C HANCOCK, SPEAKER NOTES FOR EVIDENCE IN CHIEF

I have been requested to speak on behalf of Appleford Parish Council and the Joint Parishes Council. The following represents my submitted Proof of Evidence.

I attend as a resident of Appleford . My evidence is focussed on the impact of the HIF1 road on the community of Appleford and in particular at the closest point of the road to Appleford, close to Appleford sidings. My evidence focusses on Noise and Air quality impacts. Where there is a parallel concern on noise and air quality such as at Nuneham Courtenay I will raised this concern.

AERIAL VIEW OF HIF1 CLOSE TO SOUTHERN APPLEFORD

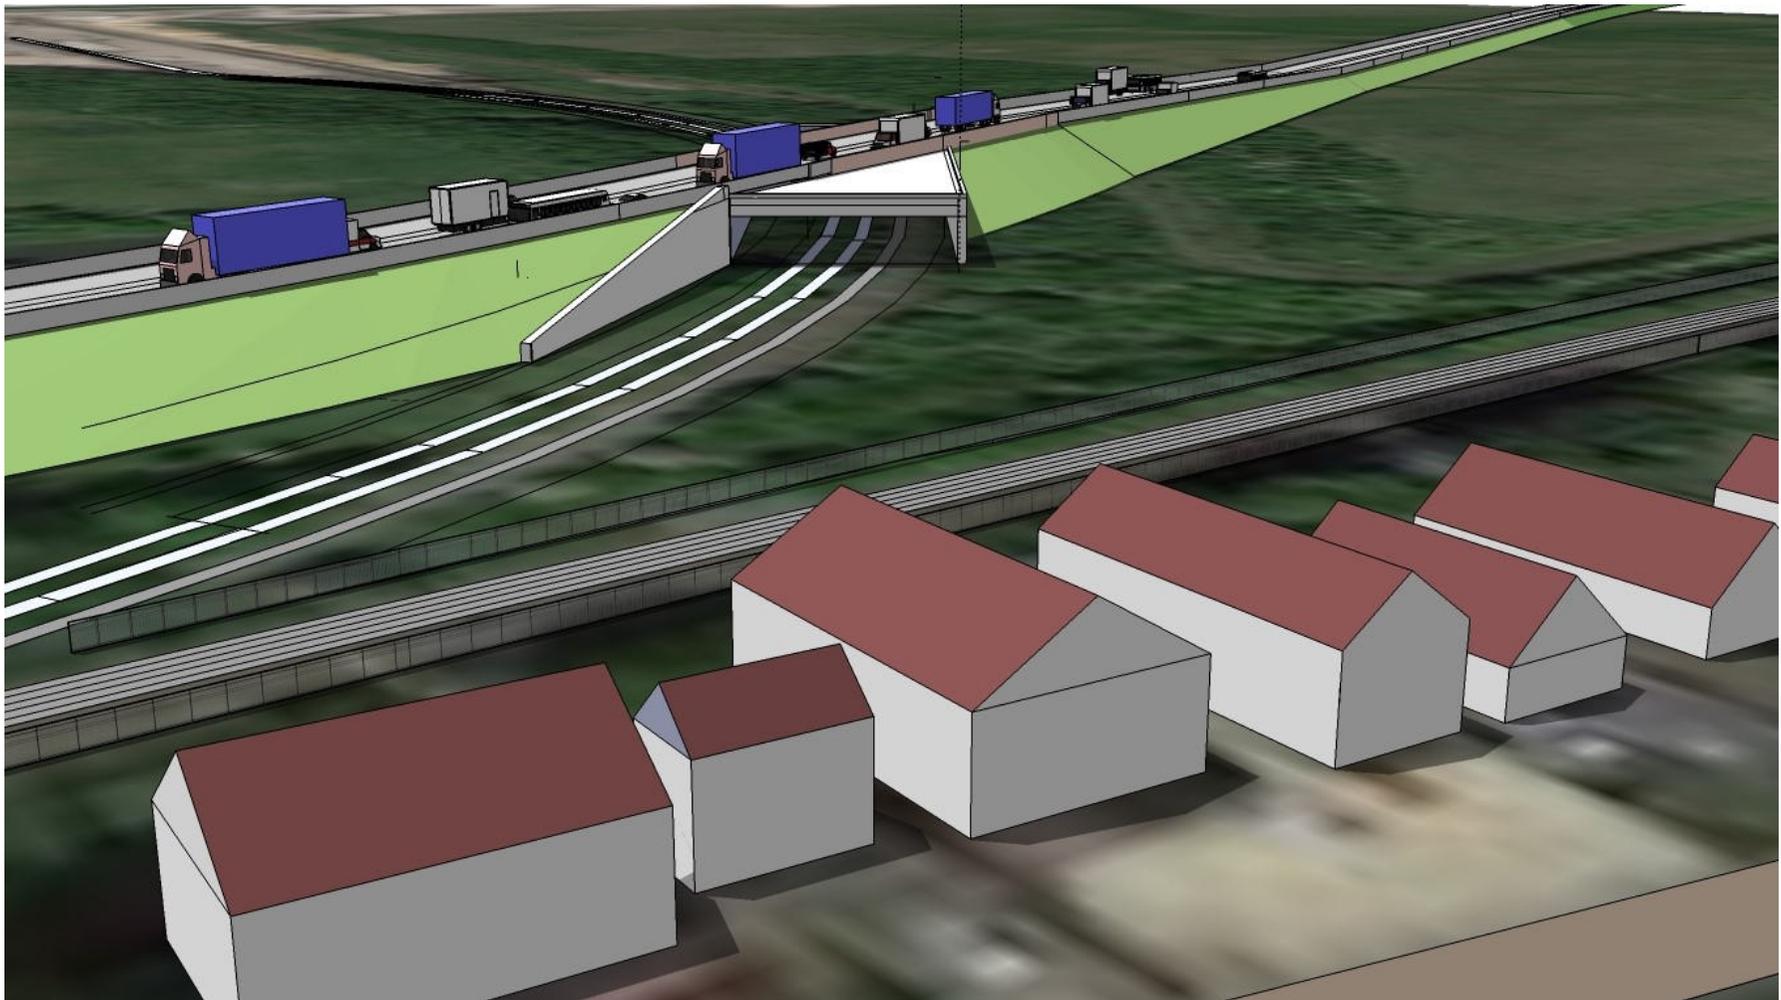
1 The relationship between the road and Appleford was not apparent to our residents through OCC’s consultation documents in 2020. Therefore we produced a 3D model to inform residents. I extract three images from this model¹. The first image shows the HIF1 embankments and road crossing Appleford Sidings close to dwellings at the southern end of Appleford. Due to the chosen position of the bridge, it forms an acute angle to the sidings tracks. The applicant has attempted to resolve this by proposing a concrete tube or tunnel over the tracks with the road lying diagonally over it. Note the position of the dwelling marked “Bedroom A view of flyover”.

The road and bridge will be a significant contributor to noise in this location.

- The elevated road will also risk impacting the air quality in southern Appleford. The total emissions from existing and proposed HIF1 sources have not been examined in detail in the ES.
- The elevated road and embankments at 11.3m high, above roof level, will be a major visual intrusion to adjacent dwellings in southern Appleford. The small woodland currently providing a screen to industrial activity will be lost.

VIEW OF HIF1 AND ADJACENT DWELLINGS IN APPLEFORD

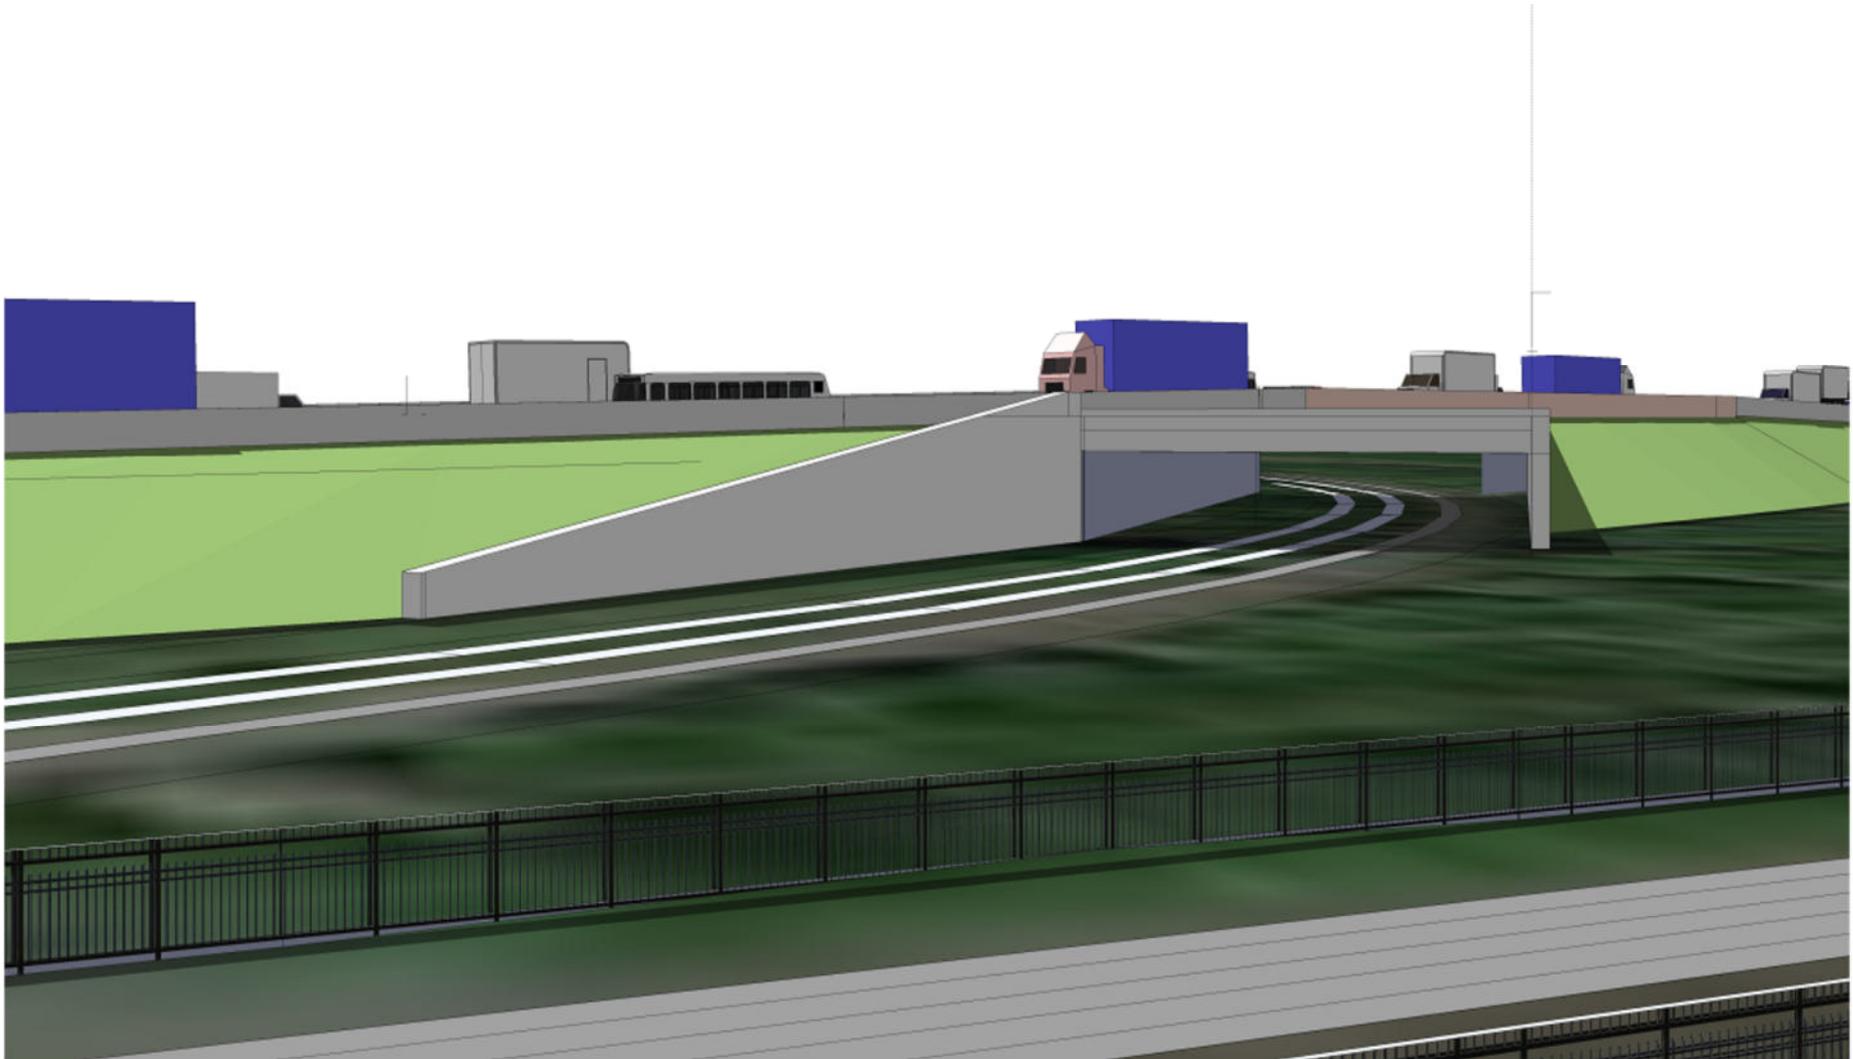
2 The relationship of adjacent dwellings facing this bridge of shown in the second image. The nearest dwelling are 60 to 70 m away.

Figure 8 Typical highway cross sections over Appleford Siding Bridge

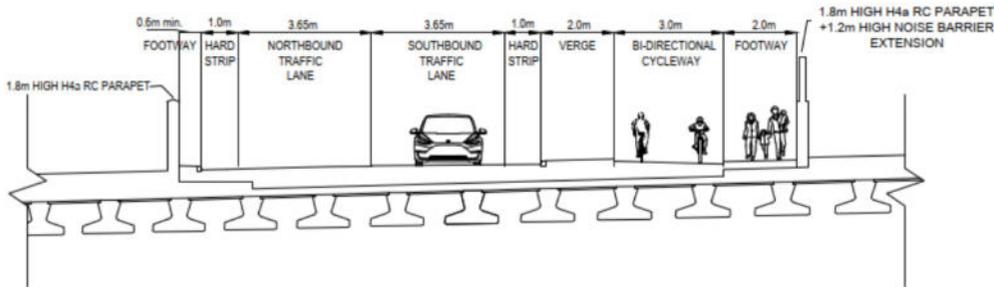
We understand that the word “futureproofing” applied to the bridges is that they are structured for vehicle loads of dual carriageways for the full width. Figures 8 & 9 of Mr Chans PoE appear to confirm this. There is a uniform base structure across the full width of the bridges. If the applicant can provide the structural evidence that this is not the case we will correct our description.

Figure 10 Typical highway cross sections over River Thames Bridge and viaduct

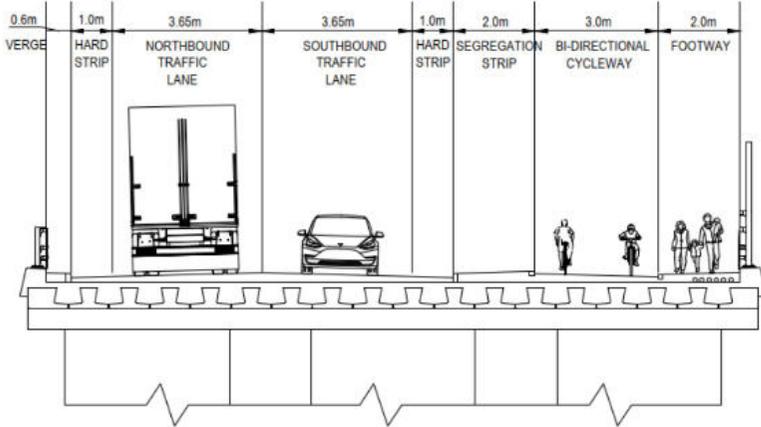
5 The three bridges consume the greatest proportion of the resources of the road, as a ball park between 60-65% of scheme resources (working from a table in the Transport Assessment). It’s hardly credible that a large investment in “future-proofing” on such a tight budget would be

for nothing. We therefore describe the bridge crossing sections of the road as ***“ultimately providing a dual carriageway arterial link between the A34 and east Oxford/ M40...”***.

Figure 5 Alternative position of bridge crossing Appleford sidings

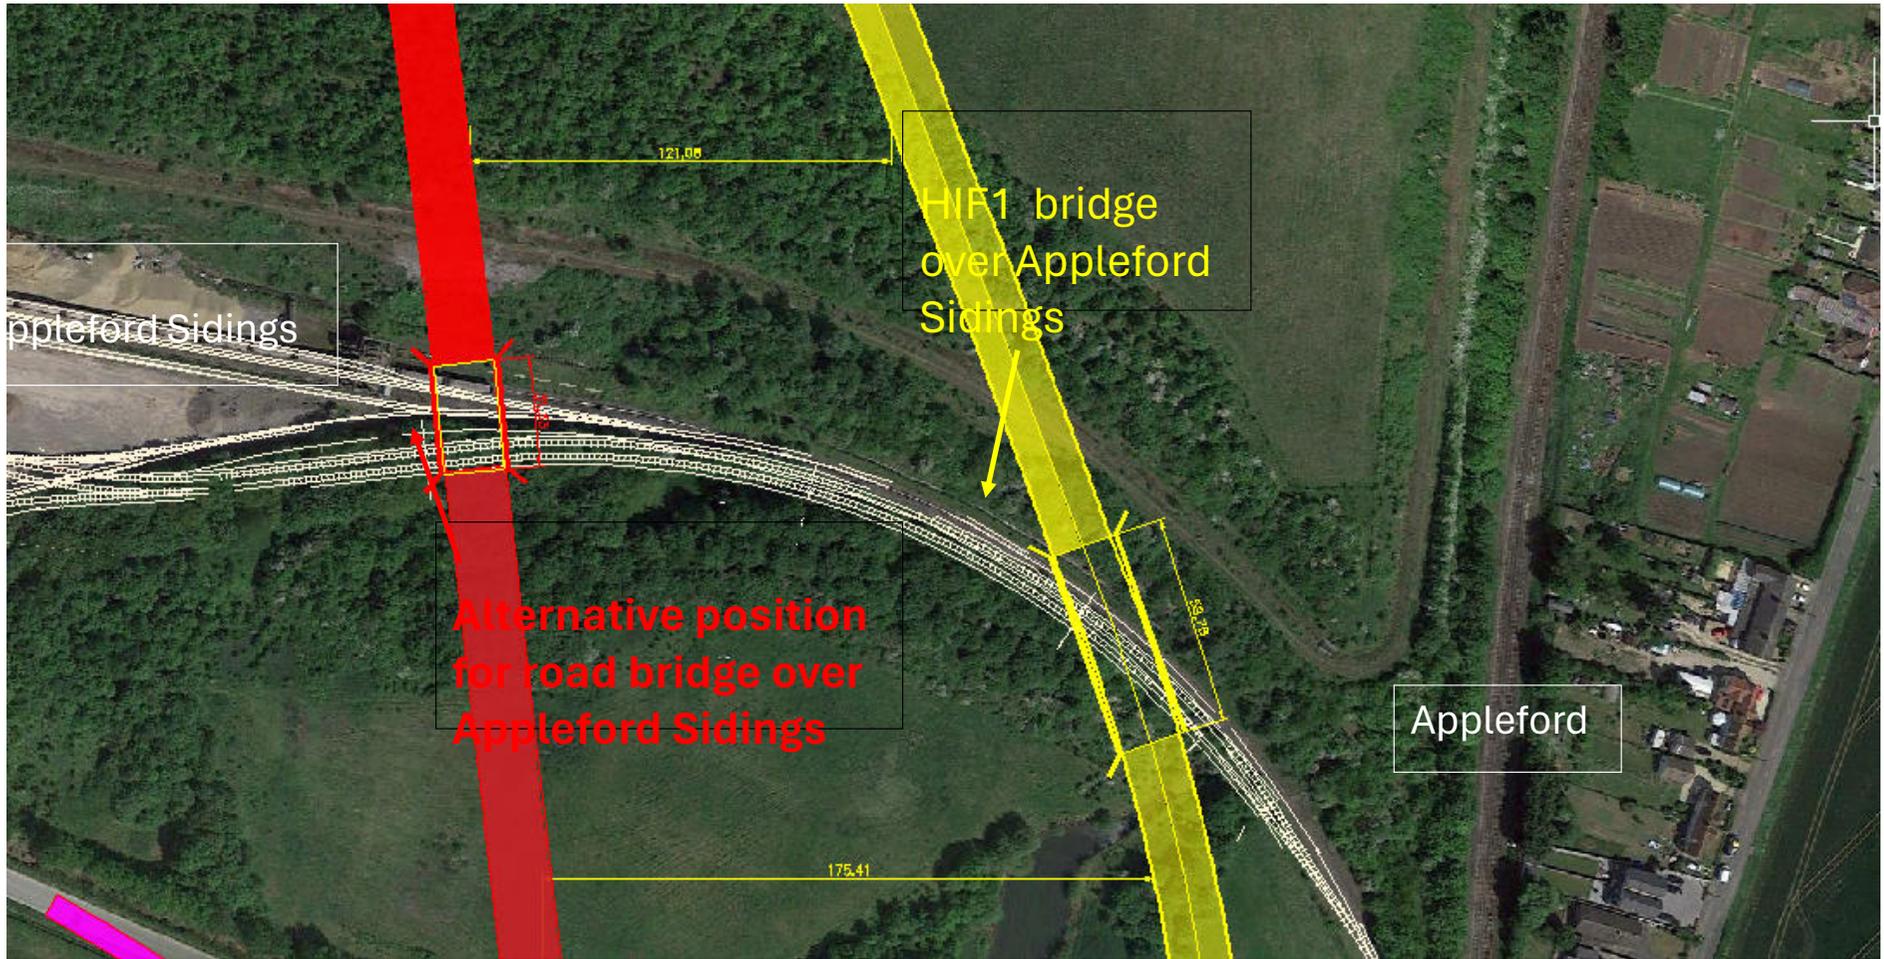
9 We have demonstrated a number alternative positions for the approach road and bridge over the Appleford siding¹⁸. This image shows a bridge crossing in red further away from the Appleford dwellings closest to the sidings, as we presented during our meetings with OCC. This is entirely viable position. And actually requires a less complex bridge.

8 If a new road is deemed necessary, the potential damage to Appleford, could be mitigated to a degree by increasing the distance between the road and the Appleford dwellings.

Alternative road bridge position over Appleford Sidings

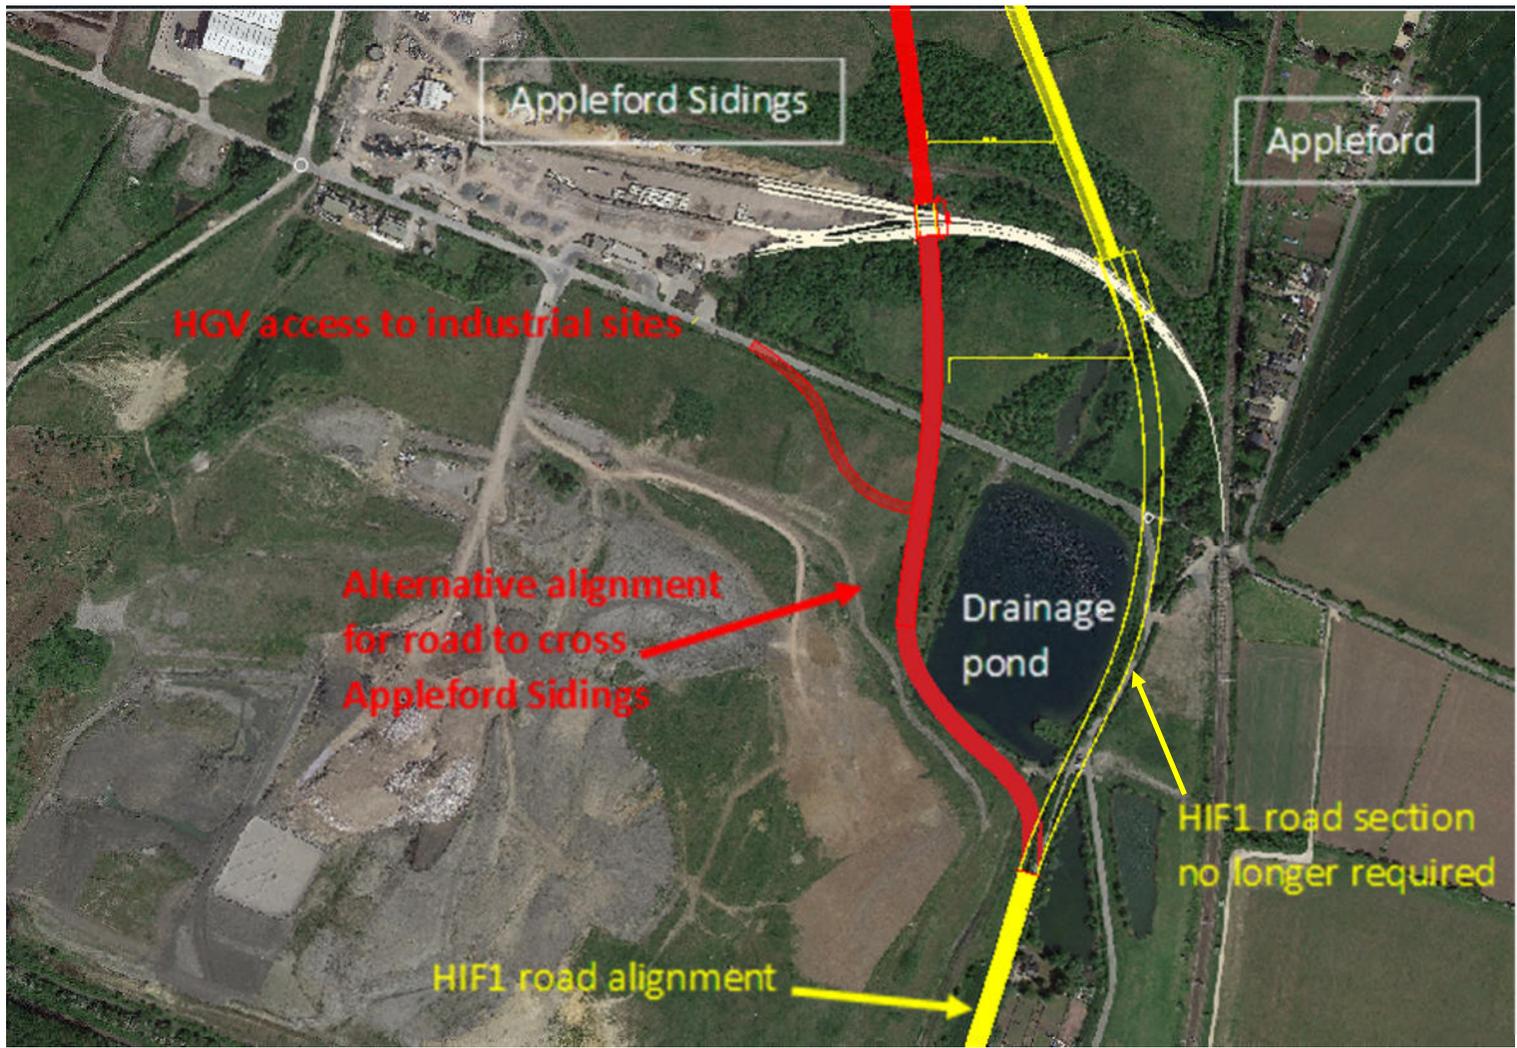
11 To bring a road from the south to this bridge could be achieved by adopting the route of the HGV road proposed in the HIF1 scheme and continuing it to meet the bridge position. This route is shown as the red road in this image, as an alternative to the HIF1 alignment shown in yellow. It could have a 30mph limit as a continuation of the speed limit of the part of the road immediately to the south.
